CITY COUNCIL MEETING STAFF REPORT

DATE OF MEETING: June 21, 2017
NAME OF PROJECT: Haven Farms
NAME OF APPLICANT: Lance Ford
AGENDA ITEM: Preliminary Approval
LOCATION OF ITEM: 1170 South Center Street
ZONING DESIGNATION: RA-1-43

Subject: Haven Farms, Preliminary Approval

Horrocks Engineers recently reviewed the above named subdivision plans for preliminary Approval. The proposed development is located at 1170 South Center Street. The proposed development contains 20 lots. The following issues should be addressed.

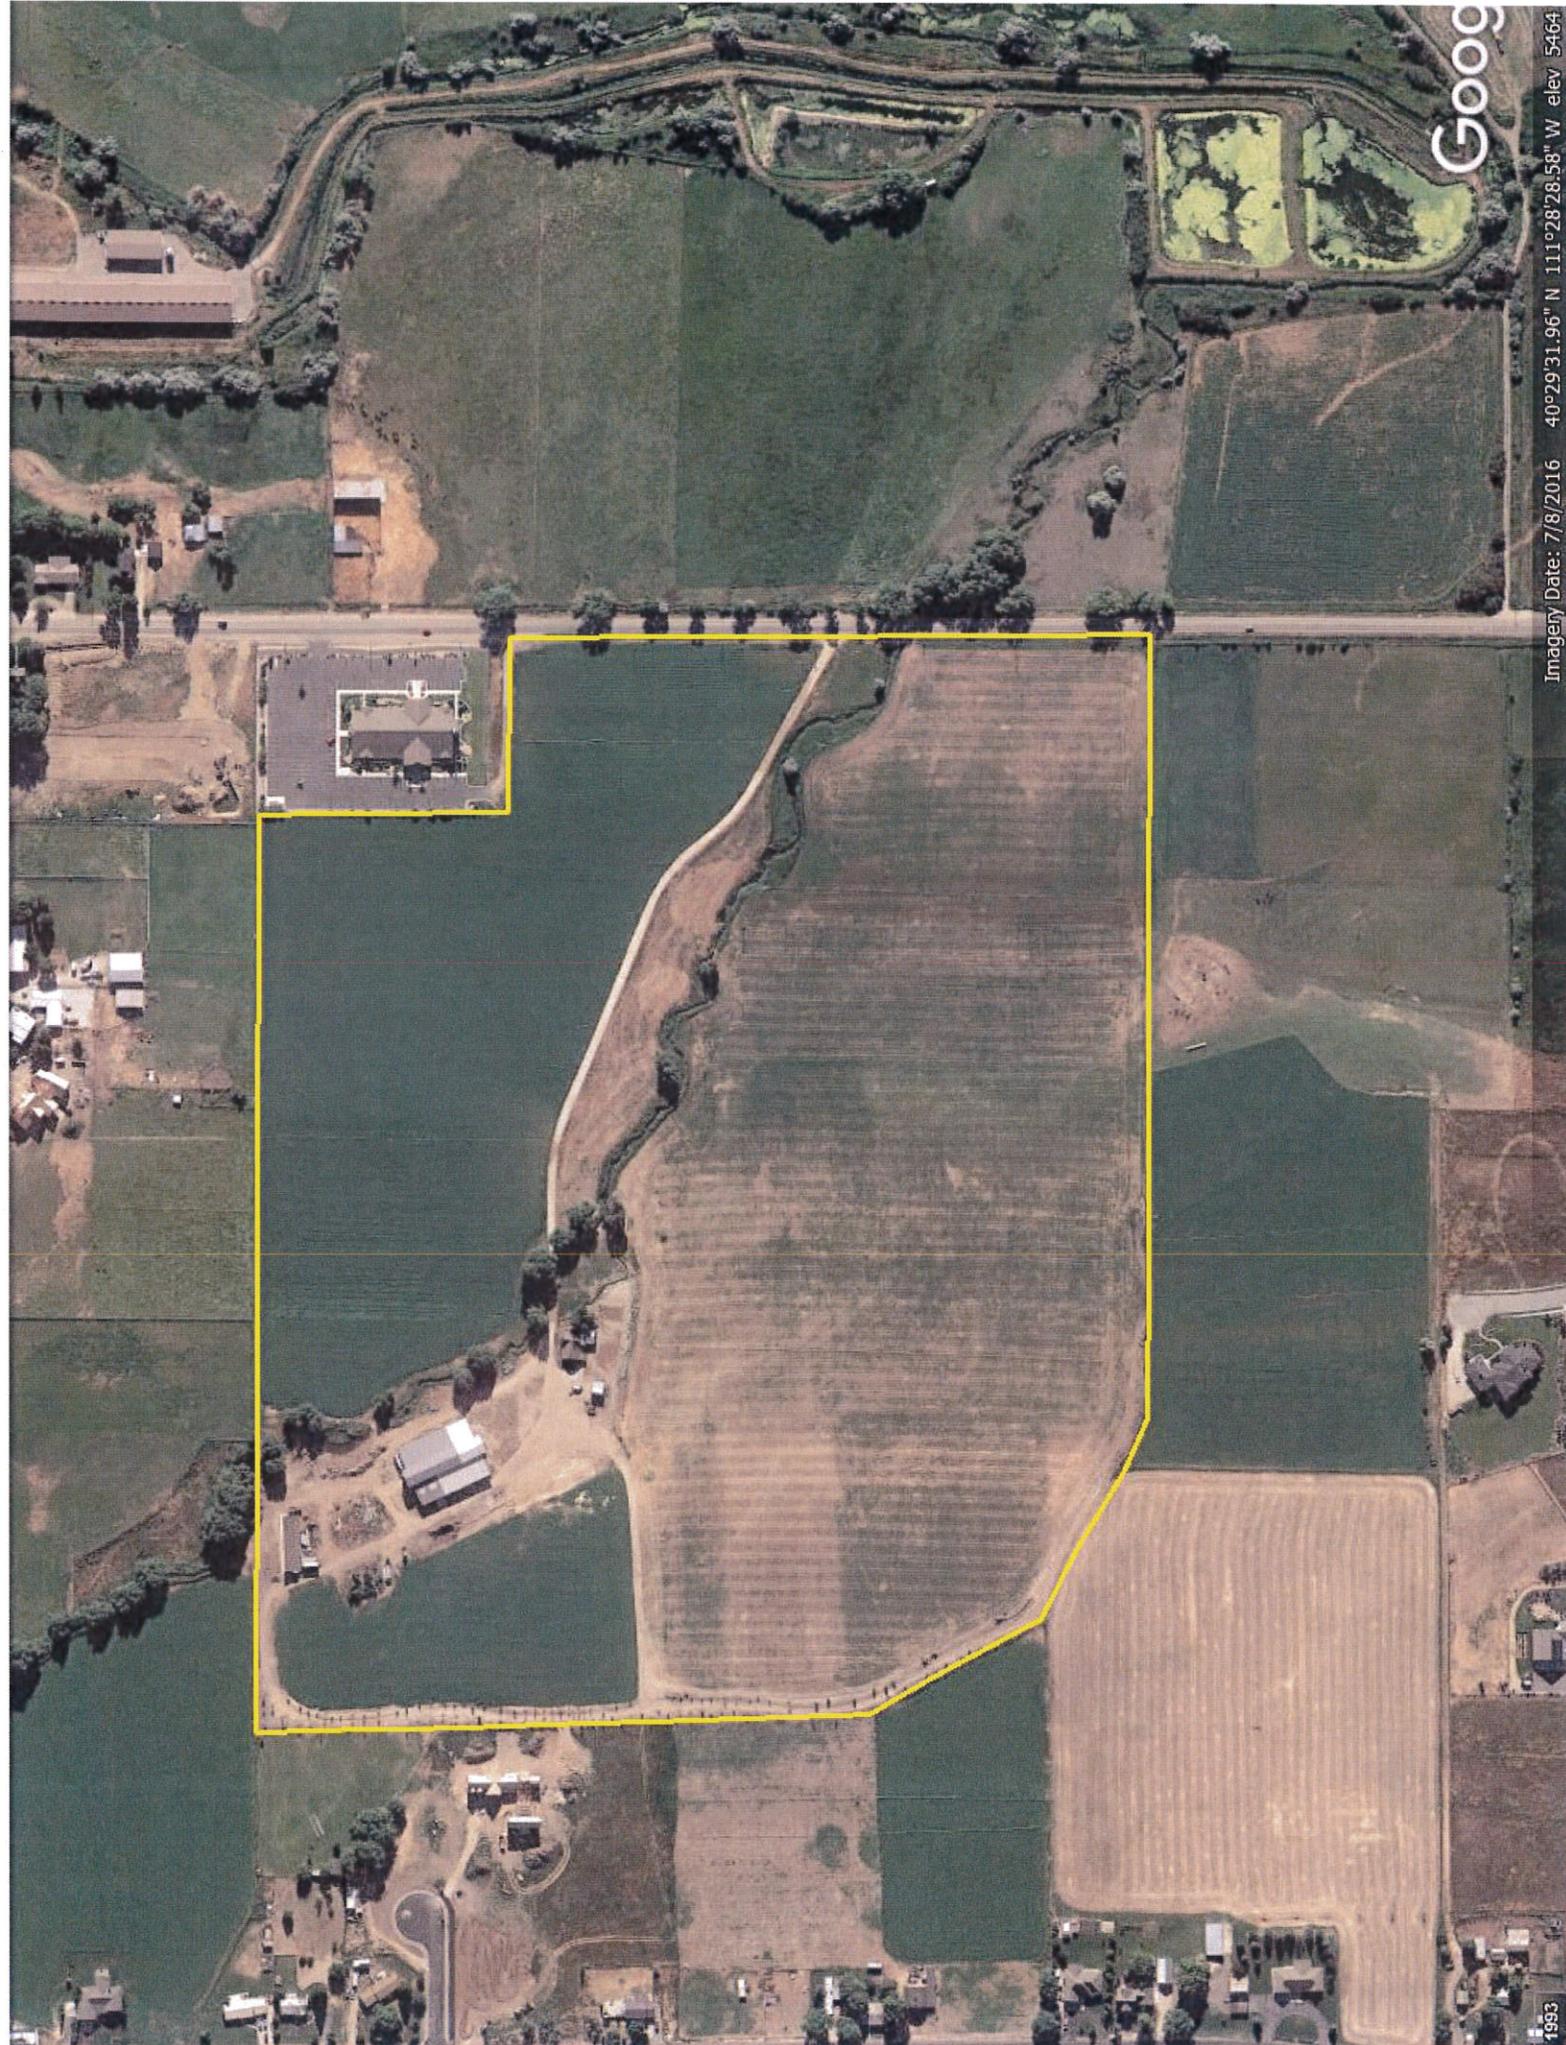
- The proposed development will be served from the Gerber Mahogany Springs zone. The proposed development will connect to the existing culinary water system along Center Street.
- The fire hydrant spacing shall not exceed 500'. A fire hydrant should be installed within 250 feet of the proposed structures.

- The proposed roadway crosses an established flood plan in two locations. Approval to construct the roadway within the flood plan should be required.
- A proposed 30' public road will be looped within the development and connect to Center Street in two locations.
- The proposed development will install a ribbon curb on each side of the road, with a walking trail on one side. The standard width of a trail installed on one side of the road is 8'. The required trail width should be discussed.

- The Midway City Capital Facility Plan show a public trail along Center Street, and a public trail adjacent to Snake Creek. The proposed Center Street trail should be straightened out and connect to the existing trail LDS Church trail and continue to the south edge of the proposed development.
- The intent of the Master Plan is to connect point "A" to point "B" and does not necessarily dictate the actual alignment. The proposed development is showing a trail connection on the south edge of Snake Creek and a trail connection near the North end of Snake Creek. The alignment of the Master Planned Snake Creek Trail should be discussed.
- The proposed subdivision is also showing several private trails within the development.

- The storm water within the proposed development will be a public storm drain system.
- All storm water details and calculations should be submitted and approved prior to Final approval. To minimize future City maintenance, all swales should be lined with a 4" rip-rap, or have lawn installed and maintained by the lot owner.
